ATTACHMENT 3
AFFECTED PAGES FOR PROPOSED CHANGES TO APPENDIX A
TECHNICAL SPECIFICATIONS
QUAD CITIES STATION
UNIT 1
FACILITY OPERATING LICENSE DPR-29

ATTACHMENT 4
EVALUATION OF SIGNIFICANT HAZARDS CONSIDERATION FOR
PROPOSED CHANGES TO APPENDIX A, TECHNICAL SPECIFICATIONS
QUAD CITIES STATION
UNIT 1
FACILITY OPERATING LICENSE DPR-2

ENVIRONMENTAL ASSESSMENT FOR PROPOSED CHANGES TO APPENDIX A

HPCI TURBINE EXHAUST LINE MODIFICATION

Figure 1

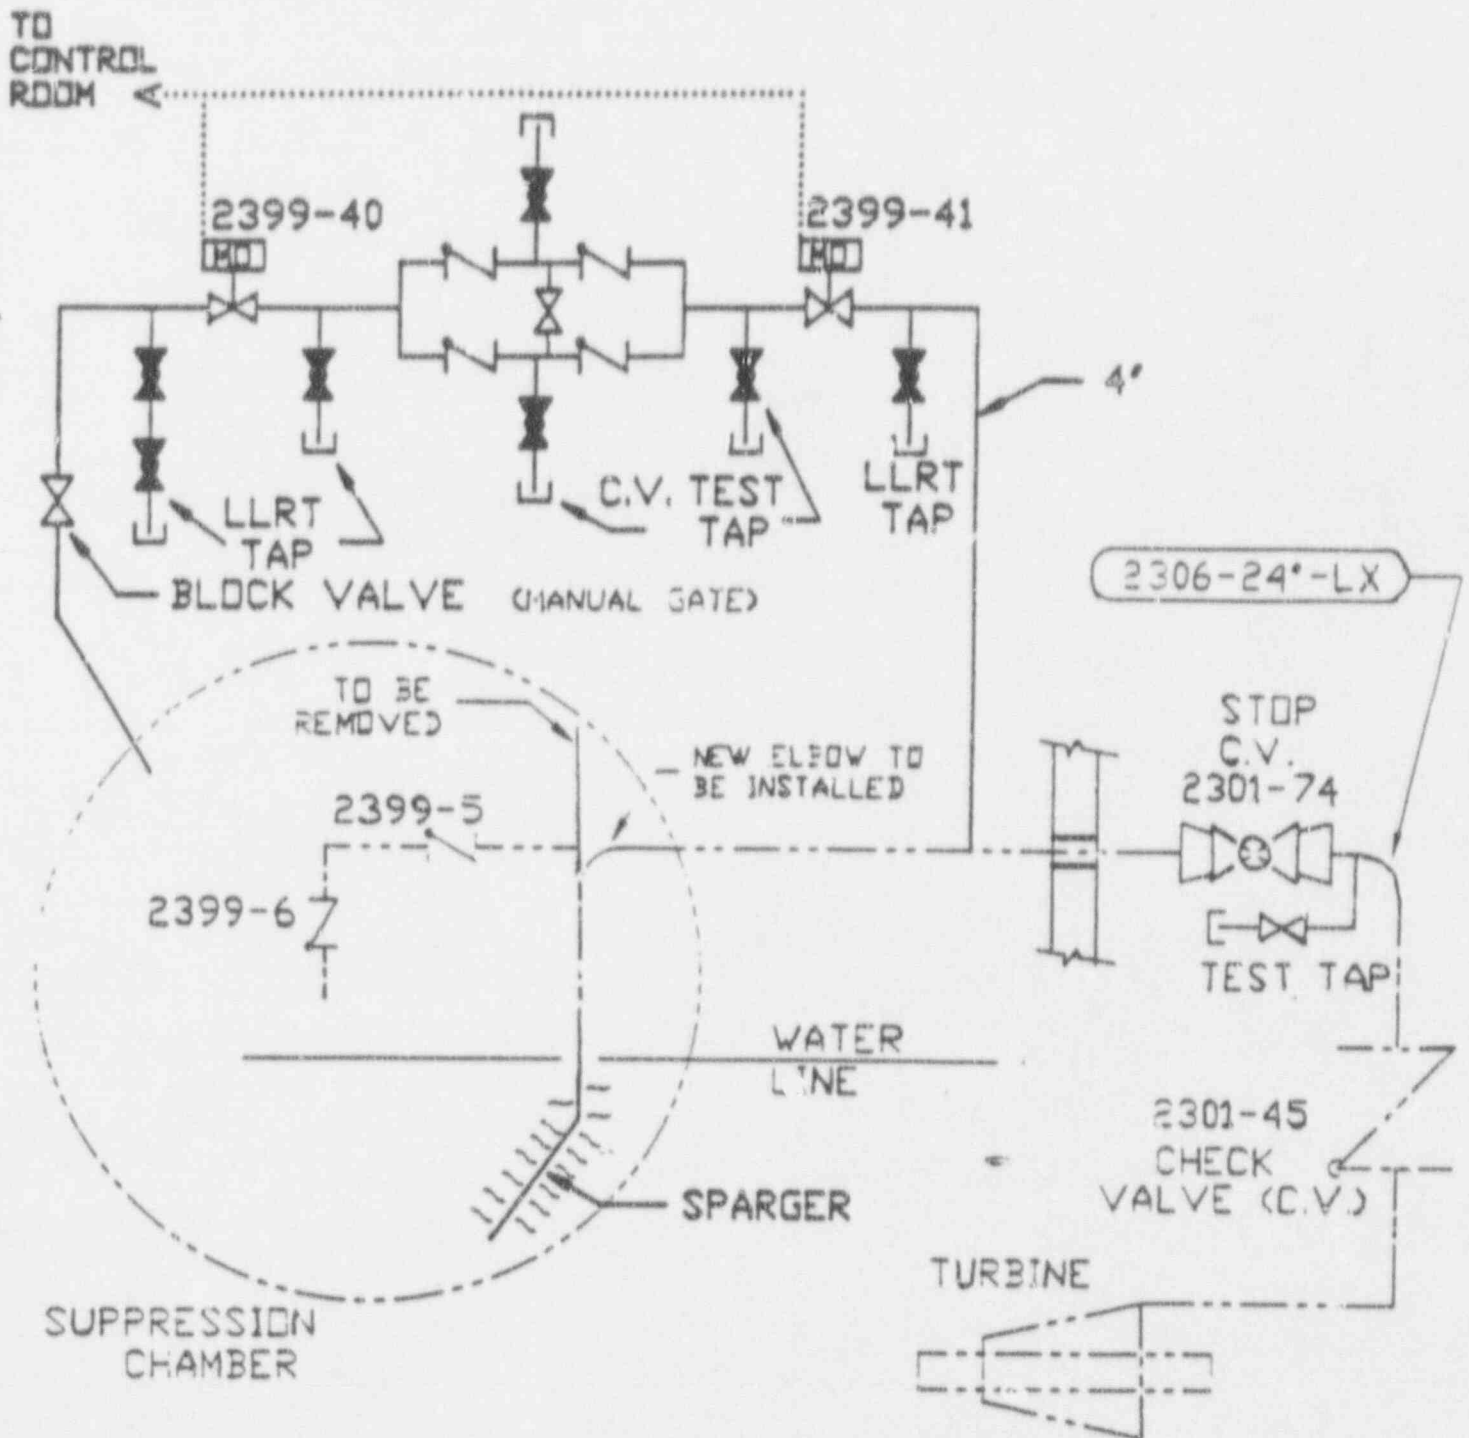
1. Reflect a proposed modification to the HPCI turbine steam exhaust line vacuum breaker configuration scheduled for the upcoming cycle 12 refueling outage. The modification will create a new primary containment boundary such that the steam exhaust line check valve 2301-45 can be removed from the 10 CFR 50, Appendix J leak rate testing program and incorporated into the Inservice Testing Program according to Section XI of the ASME Code per 10 CFR 50.55(g).
2. Amend the current Technical Specification to correct an omission of the HPCI low pressure isolation setpoint to Table 3.2-1.
3. Amend the current Technical Specification to add two new vacuum line primary containment isolation valves to Table 3.7-1.

1. A proposed modification to the HPCI turbine steam exhaust line vacuum breaker configuration scheduled for the upcoming cycle 12 refueling outage. The proposed modification will create a new primary containment boundary such that the steam exhaust line check valve 2301-45 can be removed from the 10 CFR 50, Appendix J leak rate testing program and incorporated into the Inservice Testing Program according to Section XI of the ASME Code per 10 CFR 50.55(g). The new primary containment will consist of two motor-operated 4-inch gate valves as discussed in Attachment 1 of this amendment request.

Figure 3
(Page 1 of 3)

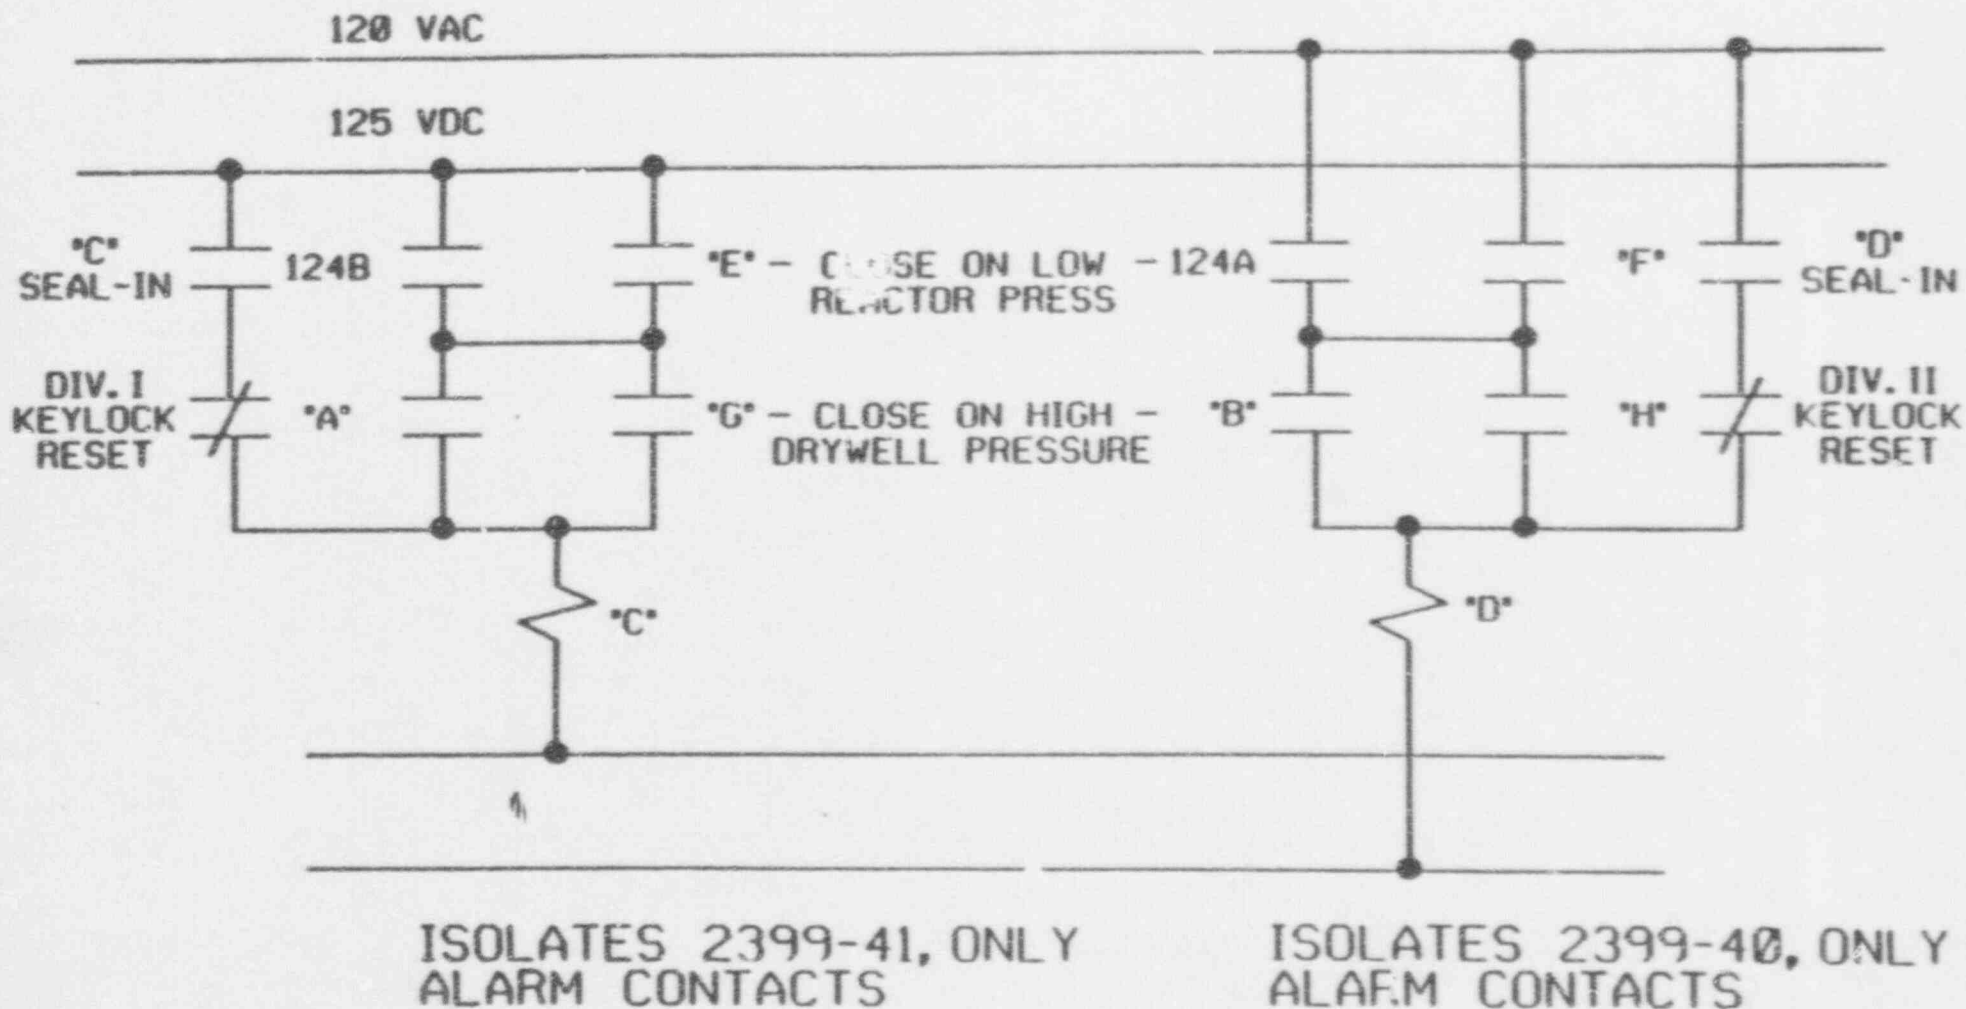
The control logic for the new isolation valves provides reliable operation for HPCI performance. The new valves will be normally open during operation. Therefore, the valves are not required to stroke from their normal position in the case of a HPCI initiation. The valves will automatically isolate on indications of a large break inside containment (drywell pressure greater than 2.5 psig) and when HPCI is no longer capable of providing pressure control and/or reactor water inventory.

"The turbine exhaust vacuum breaker isolation valves close when both of the following signals are present (simultaneously):

1. High drywell pressure
2. Low reactor pressure
